Product Change Notice (PCN)

PCN Number: **PCN-0456243R-01**

Product(s) Affected: **SJ1-353XNS series. SJ1-3533NS, SJ1-3534NS & SJ1-3535NS**

PREVIOUS CUI DETAIL/IMAGE	NEW CUI DETAIL/IMAGE

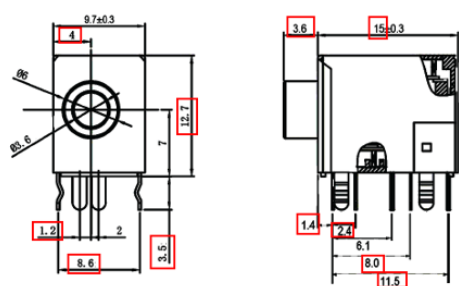
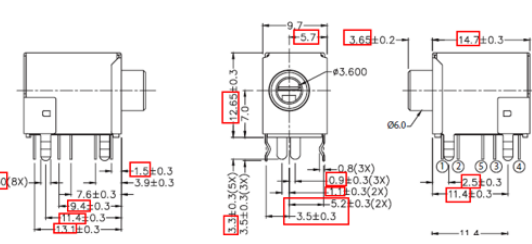
Description of Change: *New Factory Location. Product re-engineered for improved manufacturability and production yield. See image below for reference and check CUI Devices website for updated drawing. Cosmetic differences may be visible but will not affect the form fit and function of the product.*

PREVIOUS CUI DETAIL/IMAGE			NEW CUI DETAIL/IMAGE		
DESCRIPTION	MATERIAL	PLATING/COLOR	DESCRIPTION	MATERIAL	PLATING/COLOR
terminal 1	brass	silver	terminal 1	brass	tin
terminal 2	phosphor bronze	silver	terminal 2	brass	tin
terminal 3	phosphor bronze	silver	terminal 3	brass	tin
terminal 4	brass	silver	terminal 4	brass	tin
terminal 5	brass	silver	terminal 5	brass	tin
spring	stainless steel	nickel	spring	stainless steel	
bushing	brass H59	nickel	bushing	brass	nickel
shield	SPCC t=0.30	nickel	shield	cold rolled steel	nickel
housing	PBT (UL94V-0)	black	housing	PBT (UL94V-0)	black
